Contract #: 04-0120F4Cty: SF/ALA Rte: 80 PM: 13.2/13.9File #: 69.25B**QUALITY ASSURANCE -- NON-CONFORMANCE REPORT****Location:** Changxing Island, Shanghai, P.R. China**Report No:** NCR-000763**Prime Contractor:** American Bridge/Fluor Enterprises, a JV**Date:** 12-Jun-2010**Submitting Contractor:** Zhenhua Port Machinery Company, Ltd (ZPMC), Changxing Island**NCR #:** ZPMC-0725**Type of problem:**

Reference Description: Missed Indication on Diagonal Plate at North Shaft Lift 4**Description of Non-Conformance:**

Job Name: SAS Superstructure
Document No: 05.03.06-000720

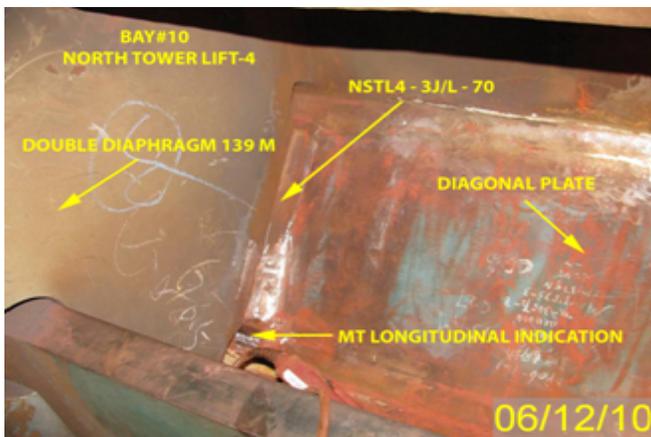
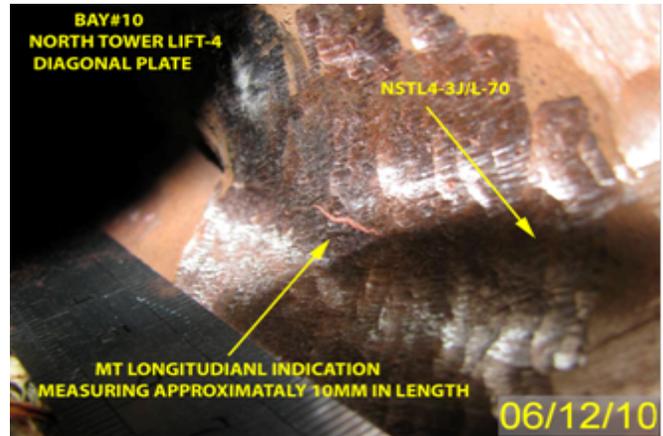
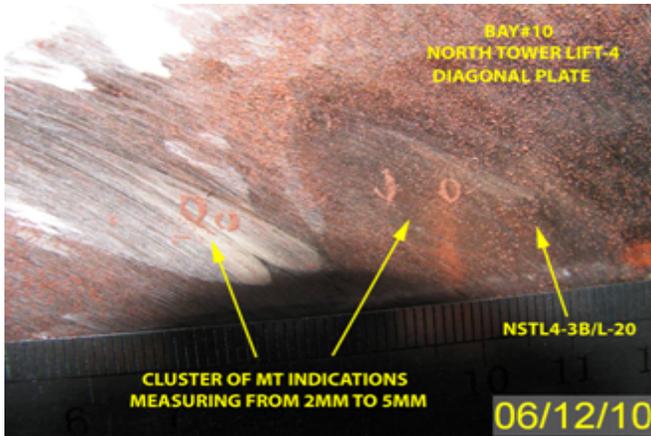
During Magnetic Particle Testing (MT) review of welds on Diagonal Plate, CD corner – North Tower Lift-4, this Quality Assurance Inspector discovered the following issues:

- Cluster of Transverse linear indications measuring approximately 2mm to 5mm in length.
- The member is identified as Diagonal Plate.
- The weld is identified as NSTL4 – 3B/L – 20.
- The weld is a Partial Joint Penetration (PJP) T-joint joining the Diagonal plate to Skin “C”.
- One (1) Longitudinal indication measuring approximately 10mm in length.
- The member is identified as Diagonal Plate.
- The weld is identified as NSTL4 – 3J/L – 70.
- The weld is a Partial Joint Penetration (PJP) T-joint joining the Diagonal plate to 139M Double diaphragm.
- The member is Non-Seismic Performance critical Member (SPCM).
- The member is located in TOWER Bay 10.

The Notice of Witness Inspection Number (NWIT) is 005962. The indication is located inside the area that has been previously tested and accepted by ZPMC Quality Control (QC) personnel. As per the contract documents,

ZPMC’s QC personnel are required to perform 100% MT inspection of these welds.

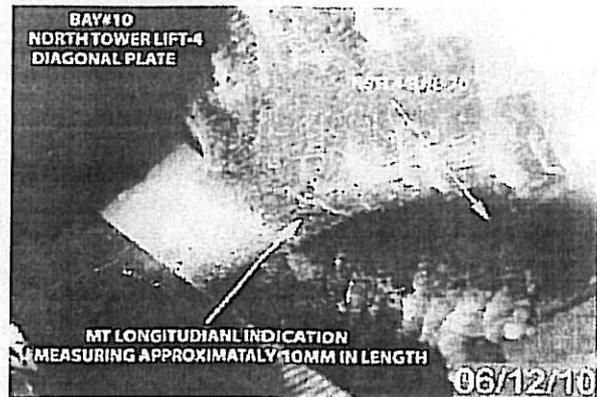
During Magnetic Particle Testing (MT) review of welds on Diagonal Plate, CD corner – North Tower Lift-4, this Quality Assurance Inspector discovered the following issues:

- Cluster of Transverse linear indications measuring approximately 2mm to 5mm in length.
- The member is identified as Diagonal Plate.
- The weld is identified as NSTL4 – 3B/L – 20.
- The weld is a Partial Joint Penetration (PJP) T-joint joining the Diagonal plate to Skin "C".
- One (1) Longitudinal indication measuring approximately 10mm in length.
- The member is identified as Diagonal Plate.
- The weld is identified as NSTL4 – 3J/L – 70.
- The weld is a Partial Joint Penetration (PJP) T-joint joining the Diagonal plate to 139M Double diaphragm.

The Notice of Witness Inspection Number (NWIT) is 005962. The indication is located inside the area that has been previously tested and accepted by ZPMC Quality Control (QC) personnel. As per the contract documents,

ZPMC's QC personnel are required to perform 100% MT inspection of these welds.
